Re: LaBrecque Autocraft
63 Newberry Road
PZC 2020-05

The following is a response to the review of the referenced application by Leonard Norton, Town Engineer, dated 04-23-20:

SITE PLAN
LAND OF
LABRECQUE PROPERTIES LLC
APN: 093-17-024
63 NEWBERRY ROAD
EAST WINDSOR, CONNECTICUT

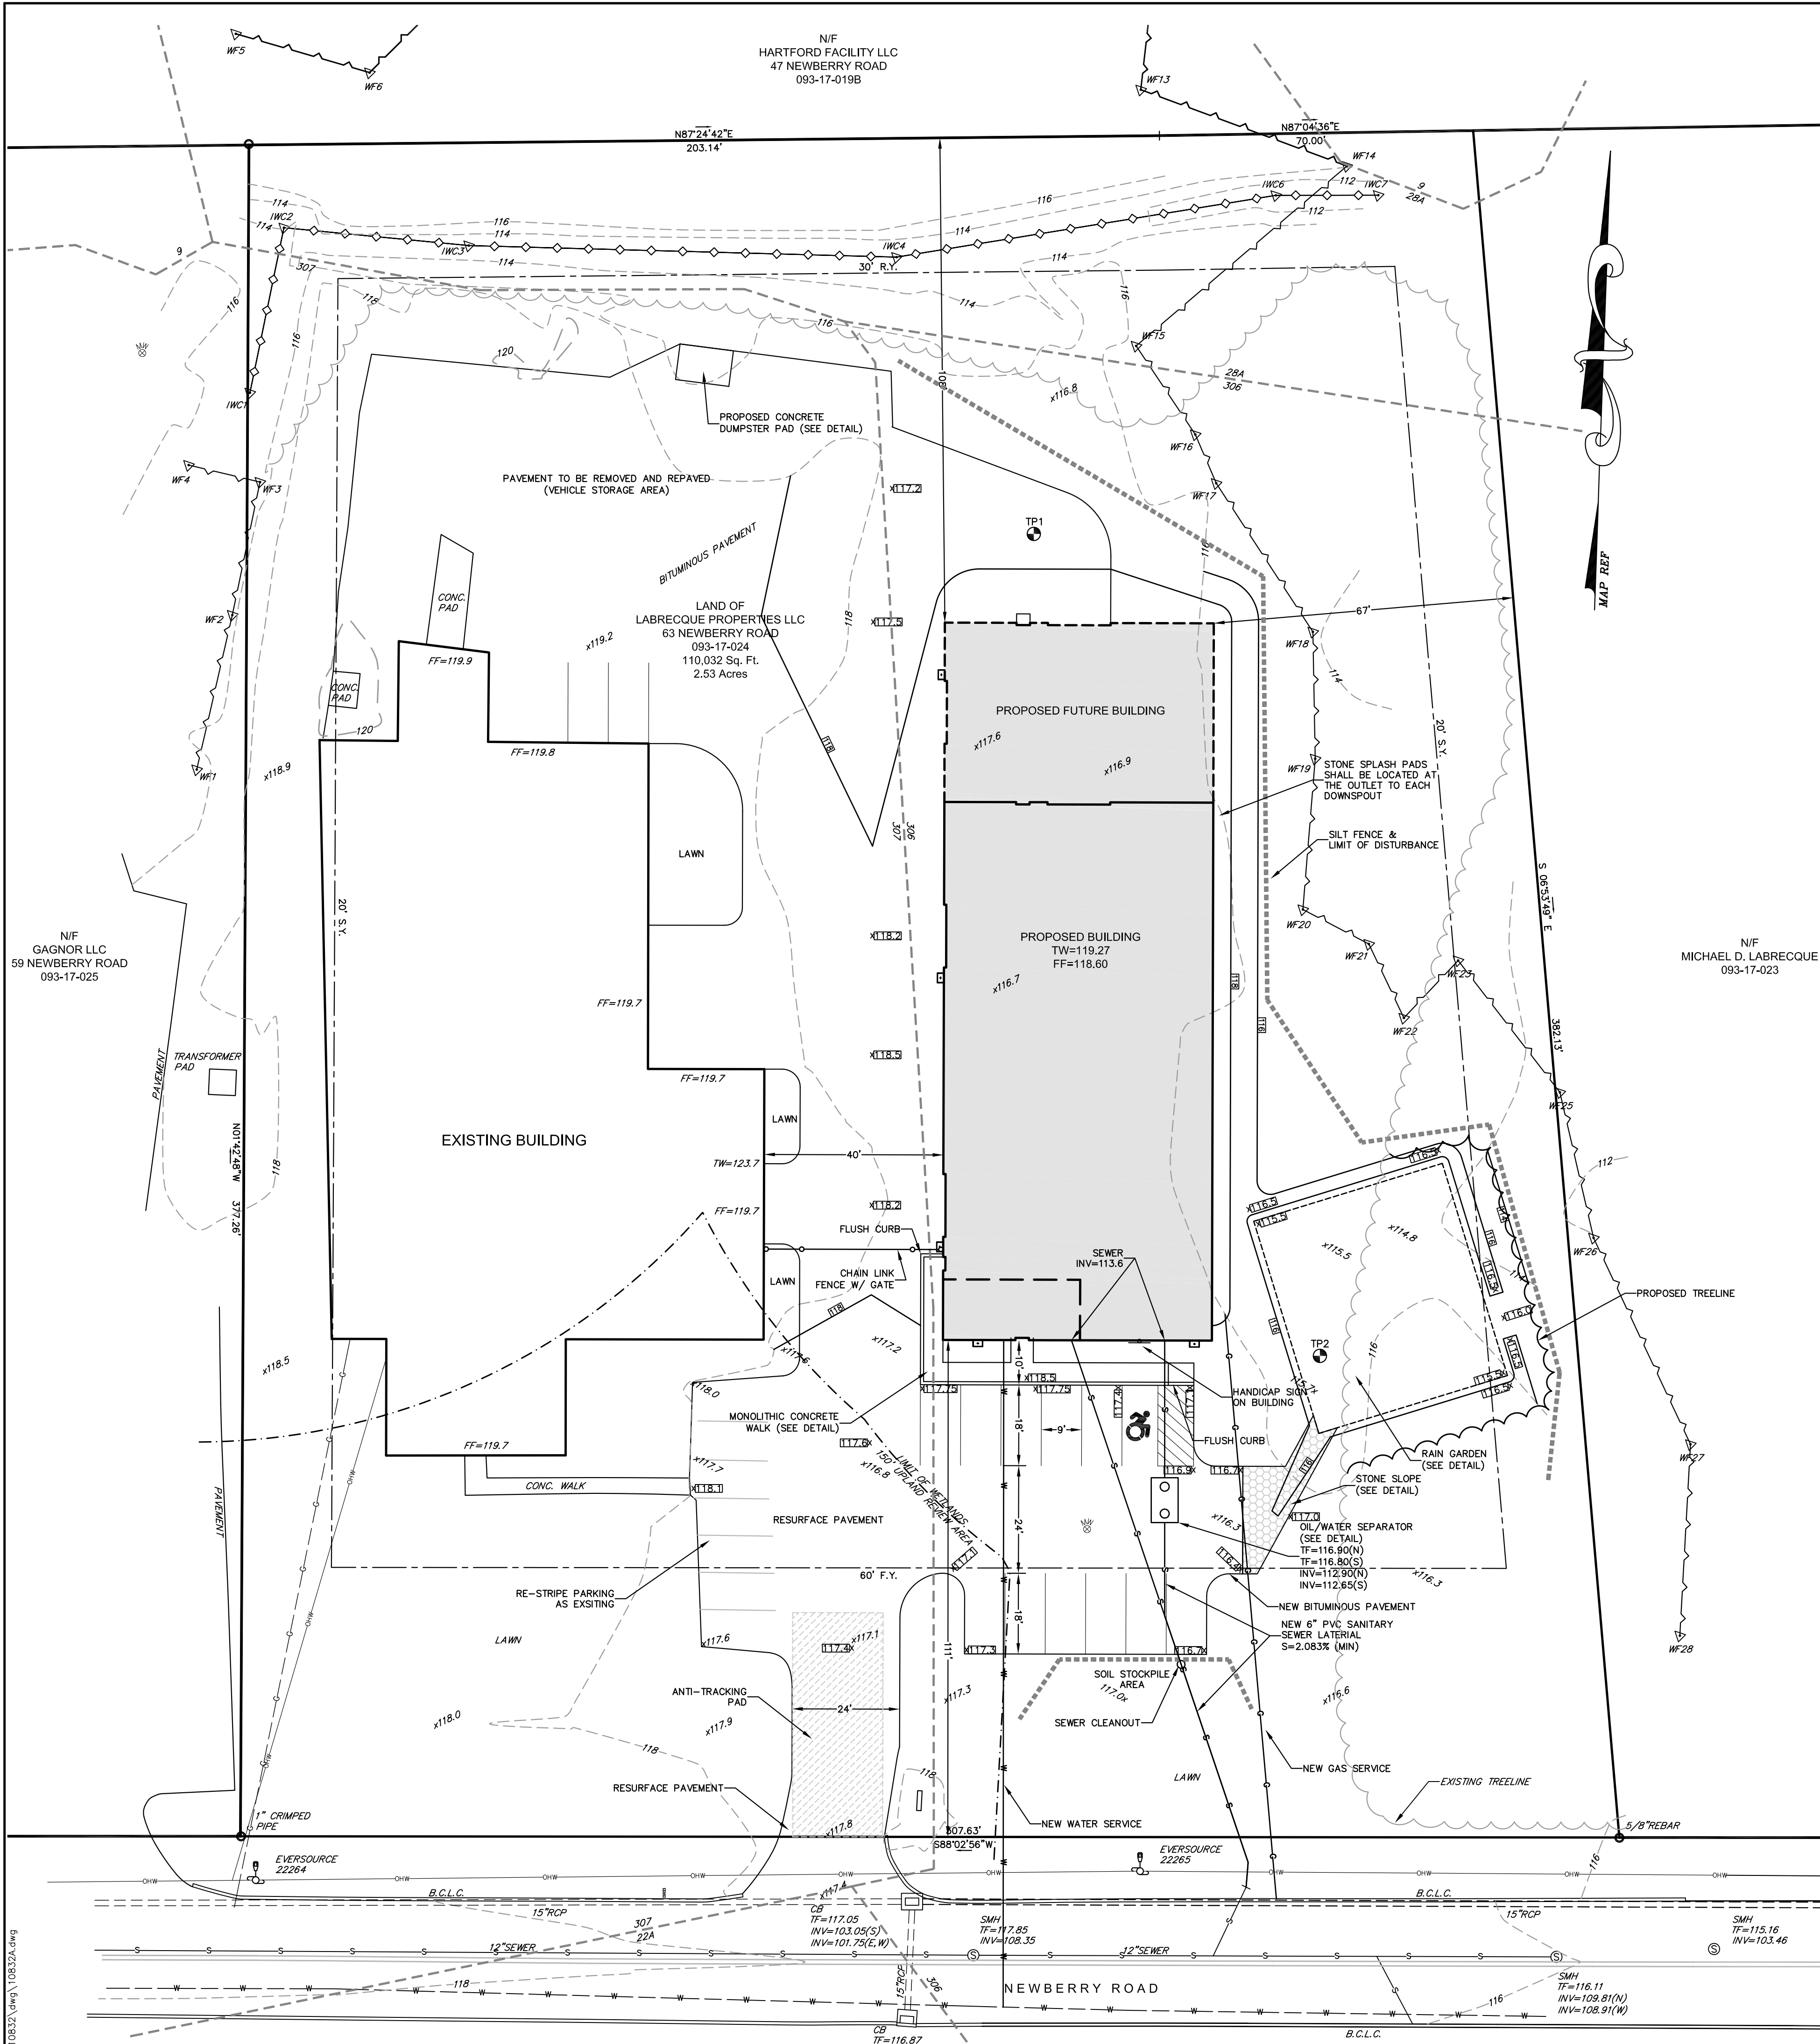
1. WPCA approval is required for the proposed sewer connection and oil/water separator.
Response: No response needed.
2. Is the sewer lateral existing to the street line or will the road need to be cut? A permit is required for any work within the Town R.O.W.
Response: According to the Town sewer asbuilt mapping a lateral has been stubbed beyond the road pavement limits. The sewer lateral for the new building will connect to the existing stub at this location. If work is to be completed in the Town R.O.W., the applicant or his contractor will apply for the necessary permit.
3. Is the pavement resurfacing an overlay or removal and repaving?
Response: The existing pavement on site will be removed and repaved as noted on the plans.
4. I recommend that a stone spreader be utilized in areas where the storm water will run off the parking lot.

8. The left side building elevation shows a sloped roof and the right side elevation shows a flat roof. If the roof is sloped toward the east, I recommend a stone splash spreader along the east side of the building to dissipate the energy from the roof runoff. If downspouts are utilized, then stone splash pads should be used at the outlets.

Response: A stone spreader has been added at the edge of the pavement where stormwater will runoff the pavement. The stone extends to the bottom of the proposed bioretention area. A detail of the stone area has also been added to the plans.

Response: The roof of the building will be sloped from west to east. The plan indicates the use of stone splash pads at the outlet from each downspout.

Furthermore, the included plans have been revised to add a concrete dumpster pad at the request of the Planning & Zoning Commission. A construction detail of the pad is also included. The pad is located such that the existing vegetation
